XDF-50

22 0F22 100650-E

NEEPC SYSTEMS, INC.		l poorion	SHEDY FEOTILES.
566 San Xavier, Sugayvale, California	ENGINEERING CHANGE NOTICE	XDF.50	SHEDY ECTIVES.
REASON FOR CHANGE:	XPN .FFECTS REV		Field Changes dequired.
Change lamp driver to 107438	OTHER DRAWINGS AFFECTED:	W XDF.20	
	DWG, NO. SHT. TYPE	MFG'G INSTRUCTIONS:	1/2
	100670-E 19 logic	All new production	
	11 280		
· 為此的名式。另一位, "是不能是我们的一个人,我们就是一个人。"			
	assy, Rur. M		
INTERCHANGEABILITY AFFECTED FIT? NO FUNCTION? No	ARTWORK PLUTE		
DESCRIPTION OF CHANGE:		•

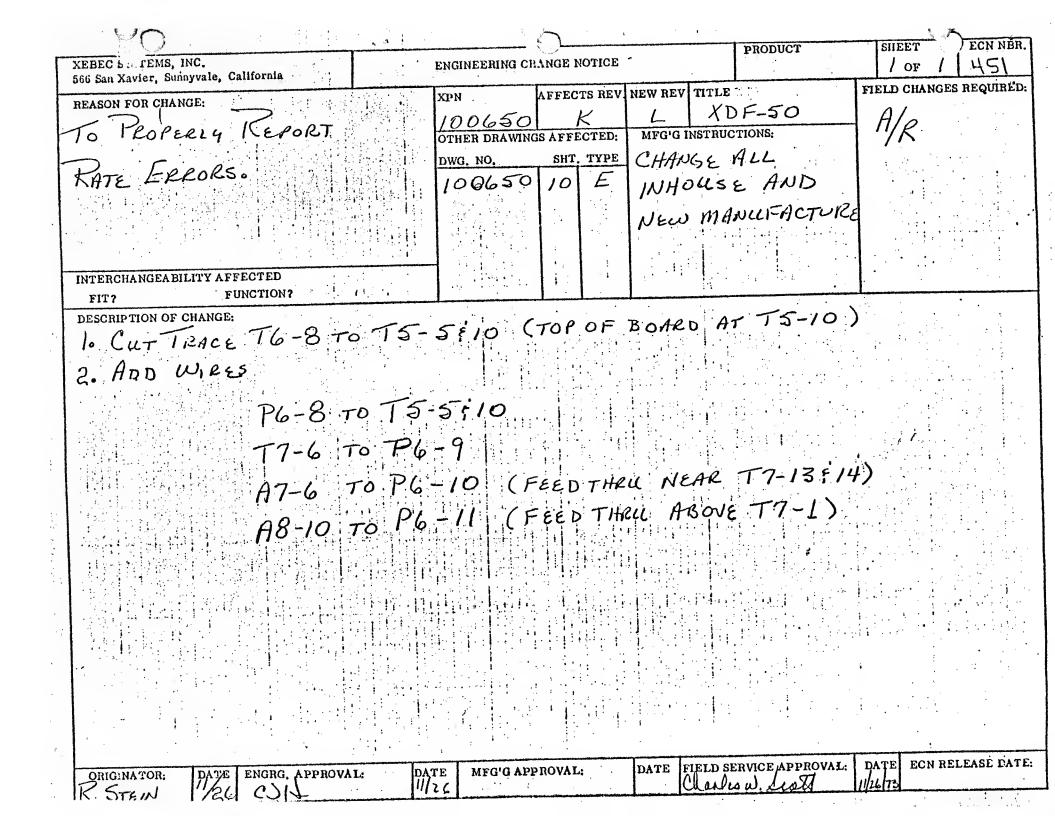
1. 100 to motal 10 7438 a	t location. Fl	DAFTING!	
2. Cut the following traces:		4. On ne	y taping: add
P1-4 (comp side)			, •
PI-6 (comp side)		150 x	redistor to GED
PI-6 (ckt =ide)		on P1	-3,6,8,11
P1-8 (cktside)			1
PI-10 (compside)

0.0010.5			
s. Add the following wires.			*
81-9 to 61-10			
P1-4 to P1-2			
P1-2 to FT off R8-8			
P1-6 to FT 066 P1-4			
Pi-8 to FT 8 P1-10			***************************************
			•
			*
SRIGINATOR: DATE ENCAG APPROVAL: DA	TE MEG'G APPEOVAL:	DATE FIELD SERVICE APPROVAL:	DATE ECH RELEASE DATE:

1. TO CONVERT LLEGAL ADDRESS Pulses	to A LEVE	NEEDED	FOR :	STATUS REGISTER.	/ e	
4) Remove trace B2-15 to D3-9,	N7-4, 51-	11. (Lea	ve BZ	-15 connected to	14-2)	4

b) Remove trace D3-8 to F11-4.	^,					
		00			4 1 1 1 m	= 1
C) ADD 'D' FLIPFLOP (SN7474)	T LOCATIO	$j \in I$				
e) ADOTRACE B2-15 to F1-10	•			WAS		•
f) ADD TRACE K2-10 to F1-11.			B2-	15 9 0308		11-4

9) ADD TRACE D3-4 to F1-13.			J4-2		•	7-4
h) ADD TRACE FI-8 to N7-4,	1 '				51	1-11 1-2
i) ADD TRACE FI-9 to FII-H.			• • • • • • • • • • • • • • • • • • •	SHOULD B

J) ADD TRACE GND to FI-7, FI	-12.		132-15 14-28	10		4-2
K) ADD TRACE VCC to FL-14.			. 40	12 610 9	F	11-4
			K2-10	, 11		
				F1 F1 7474 8		
			•	7/3		7-4 1-11
			D3-4			-
ORIGINATOR: DATE ENGRG, APPROVAL: DATE	MFG'G APPR	DVAT. I	Ame lere	ET D CEDUICE ADDOMA

3) TO AllOW SEPHRATE HEAD PLATTER AND SEEK COMPLETE INVERSION.	
b) Renumber per diagram	
c) Remove trace M3-14 to K8-4. (LEAVE M3-14 connected to K8-2, K8-10, N3-11)

d) Add trace M3-16 to K8-4, N3-6.	
NEW	
NOTE: OLD M3-1 thru 7 becomes NEW M3-	2#1.8,
$\frac{1}{3}$	1 1
010 m3-8 three 14 becomes New M3-9+	hyu 15
7 8 3 4 4 4 5 6 6 6 6 6 6 6 6 6 6 6 6 6 6 6 6	
ORIGINATOR: DATE ENGRG, APPROVAL: DATE MFG'G APPROVAL: DATE FIELD SERVICE APPROVAL: DATE ECH RELEAS

4. To shorten Read clocks and	rea	ed clock	delaye	d fo	ov pv	oper oper	Aio	9	
2 400 rpmo	-						•		.:
	• •		T		*	•			
a) change resistor @ K7-1	3 .	from 15	4: to 10	k.	1.				• .

b) change resistor @ 19-1	ر غ	ر ر		1.1.				• ;	
70) 1	- Trom [5]	. 40 9·	I K					
c) CHANGE RESISTOR @ J8-1	3 f	rom 15K	to 1.0	k.				• •	
5. To correct melfunction circuit	<i>t</i>								
								0	*

a) Remove trace A 3-1 to L	4-13	3. (LEAL	L A3-1 0	Lonne	sted to	· 12-12)	. •	00	
b) Add trace B4-6 to L4-	12						•	*	
37.60	، ،		± ' '	:			i		<u> </u>
				1

- I. CHANGE VALUE OF TIMING RESISTOR ON H8-13 TO BE 5.1 K
- 2. ADD 27 PF. CAP. BETWEEN HB-11 & HB-13.
- 3. CUT TRACE T3-2 TO T3-13.
- H. ADD WIRE T3-2 TO T3-1.
